**TENDER 16-20**  
**WATER TREATMENT BUILDING**

**ADDENDUM NO. 2**

**September 23<sup>rd</sup>, 2016**

**Addendum Item 1**  
**Questions & Answers**

**3 SANITARY FORCEMAIN PROFILE**  
SCALE: 1:500

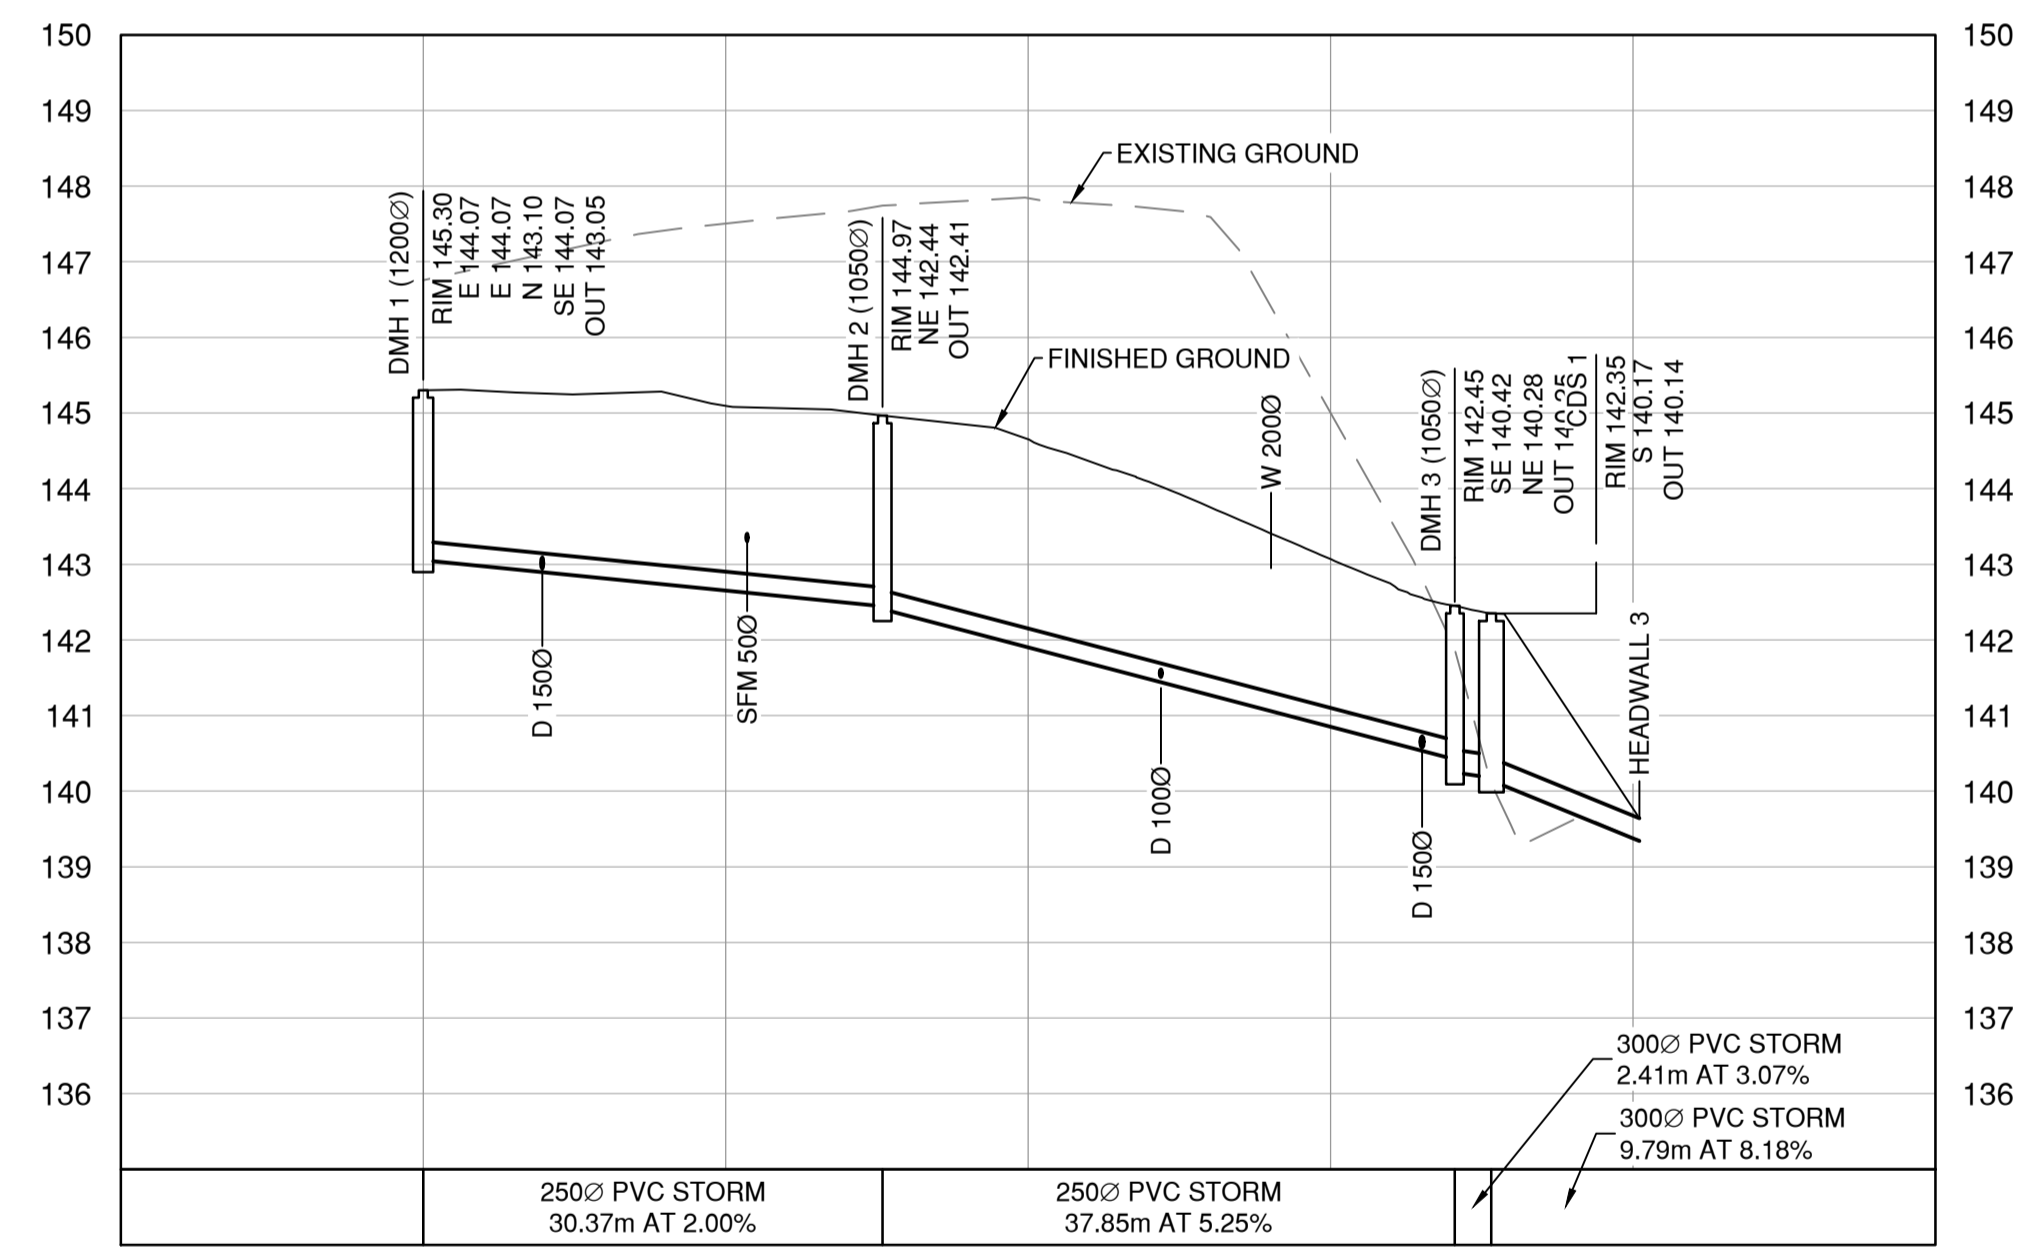
Regarding the drawings, the pipe says it is supplied by Owner - see drawings C105 detail 1 and C201 watermain profile.

The drawings have been modified to clarify that the pipe supply is by the contractor, see the revised drawings attached.

DRAWING NO. 15-508- S102
PROJECT: 11231316
REV. 2

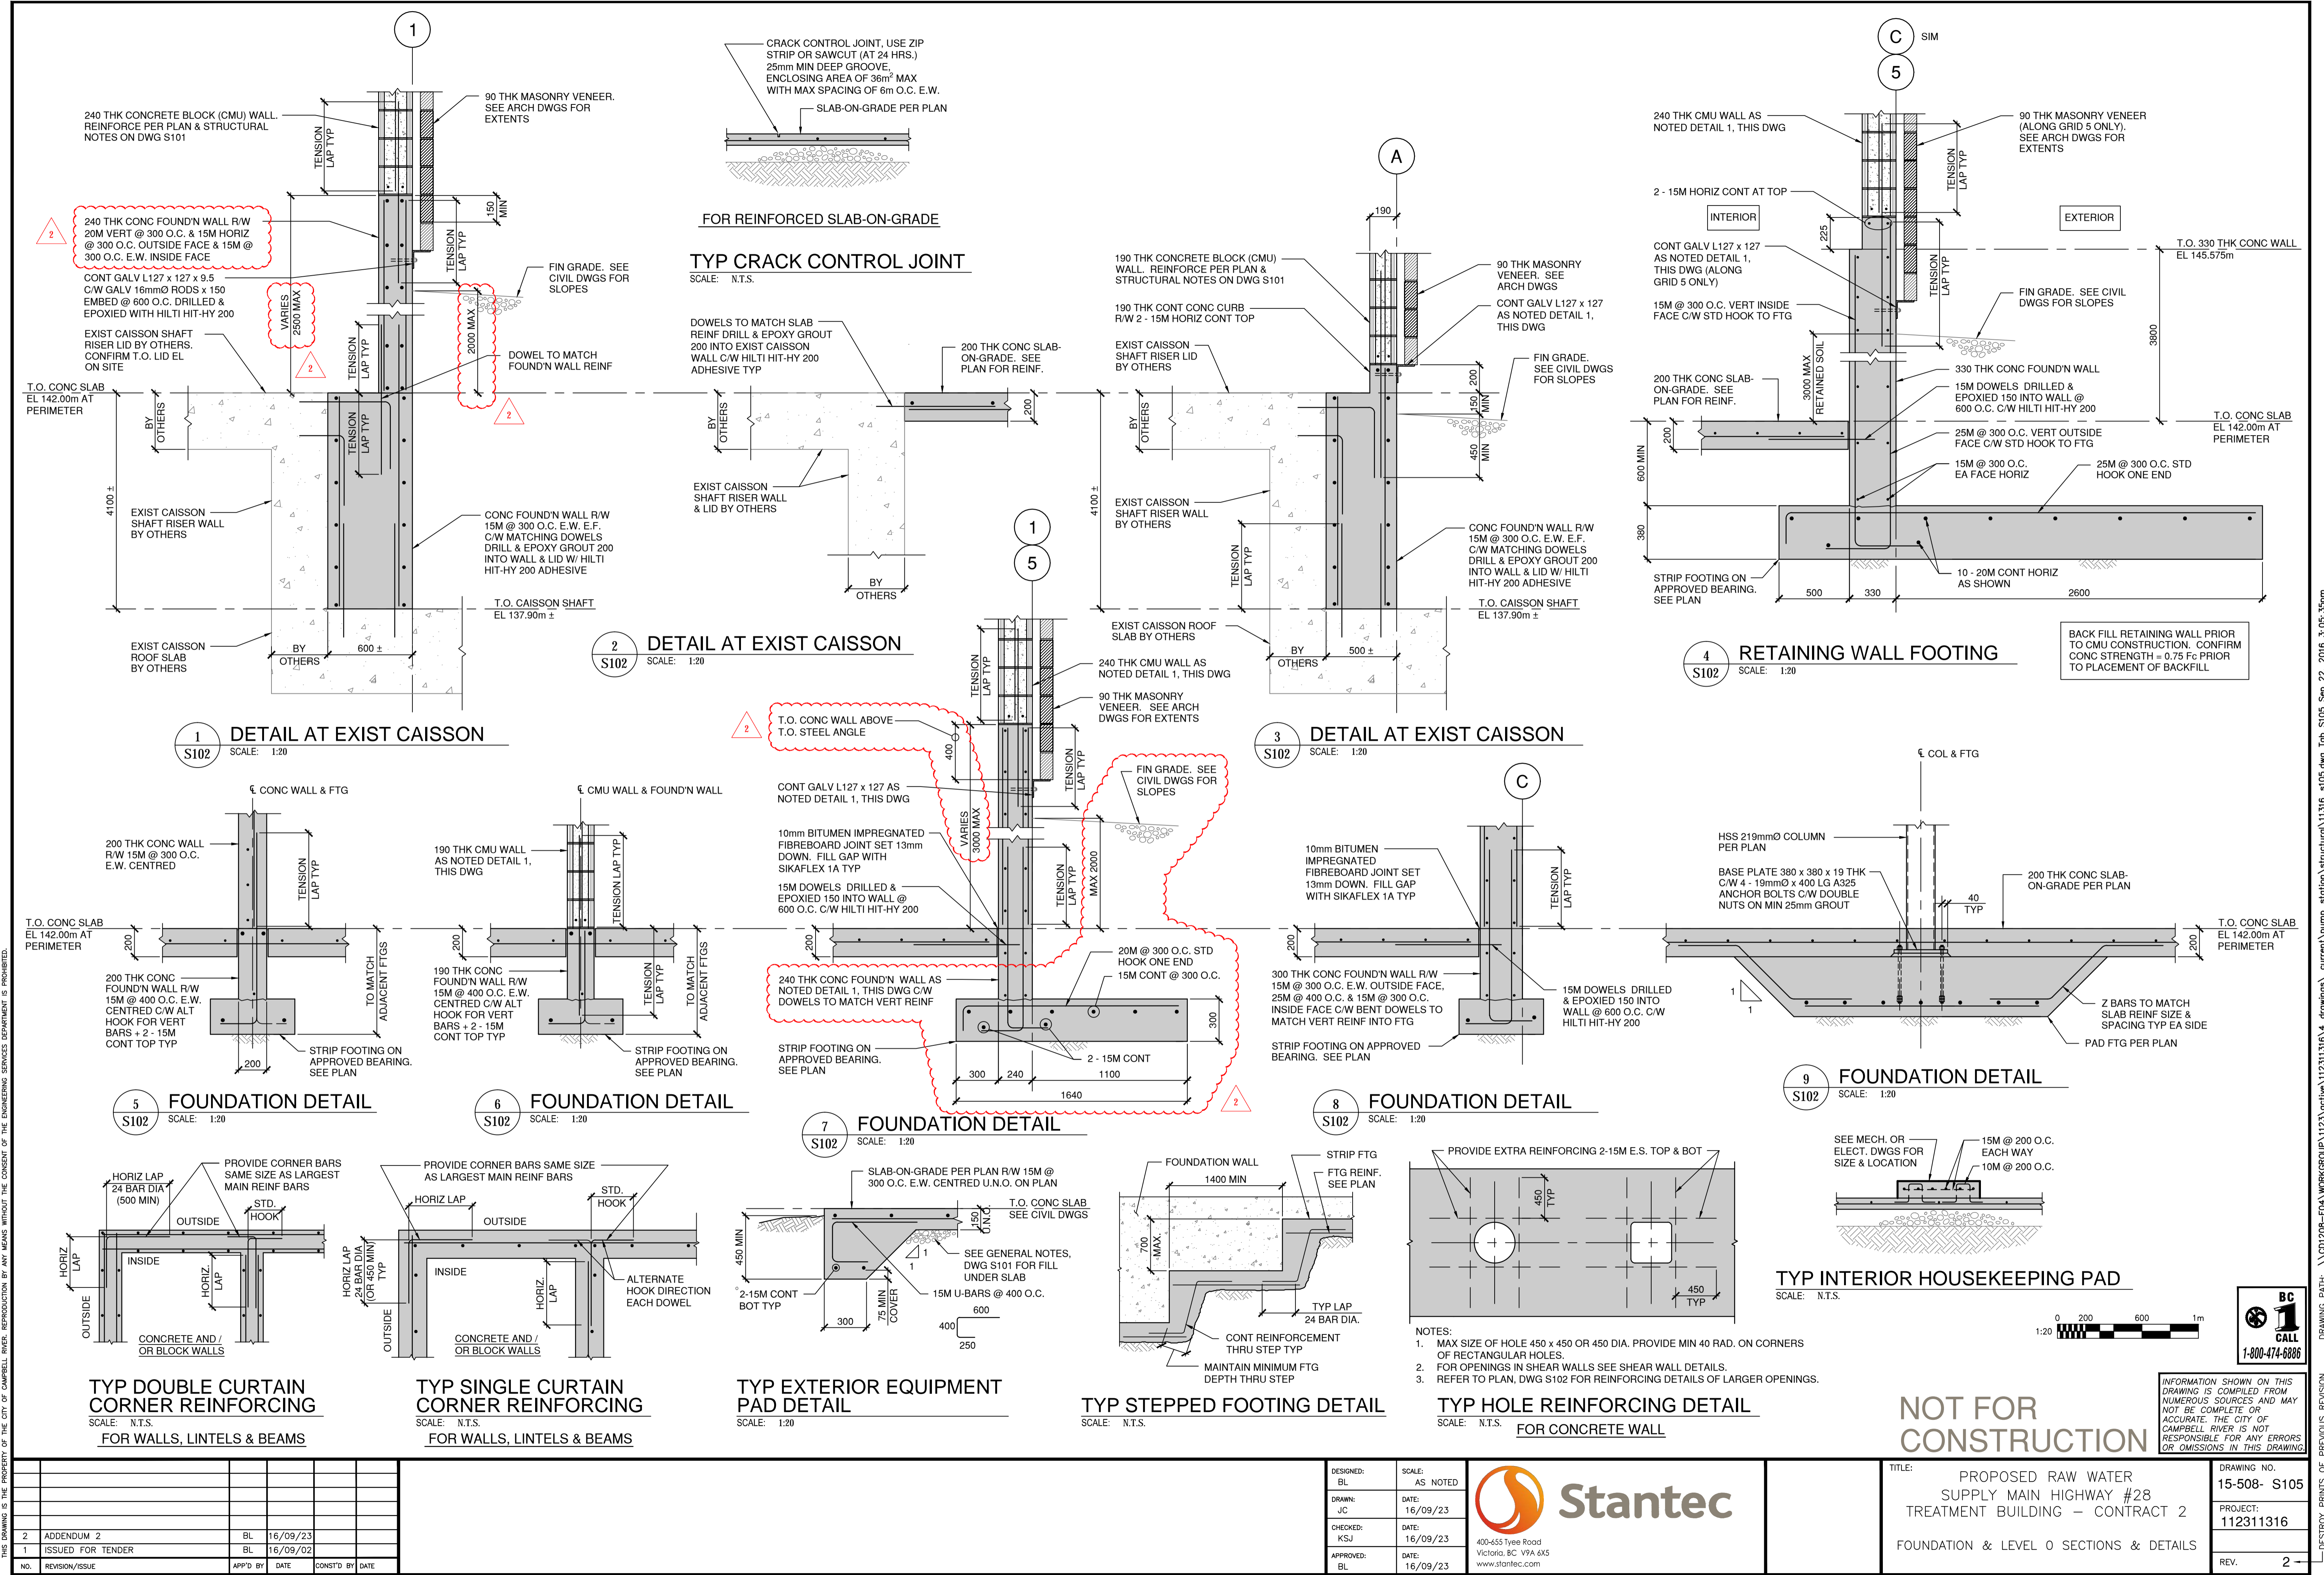
S102 - Please clarify the phrase in Note 8 - Soil shall be improved as required by the geotechnical engineer. Refer to the Geotechnical Report. This implies the bidding contractor's responsibility to address ANY and ALL found conditions, deficiencies in soils in bearing and seismic abilities.

S102 – Note #6 refers to Architectural drawings for all slab recesses - Architectural does not reference or layout the 2 meter deep trenches

S102 - If Existing Shaft Riser Lid is to be by others why are we told the design requirements and why are we to co-ordinate several hatch openings with Process. Please clarify the intent and what contractor is responsible for what work.

The contractor is responsible for improving/preparing the soil as noted in the geotechnical report. Any found conditions will be addressed under the direction of the geotechnical consultant in order to achieve the foundation requirements.

The layout of the trenches is clarified in the attached drawings.

The shaft riser with slab openings and the installation of the steel hatch (provided by the City of Campbell River) is part of contract #1. The concrete curbs around the riser slab openings is part of contract #2.
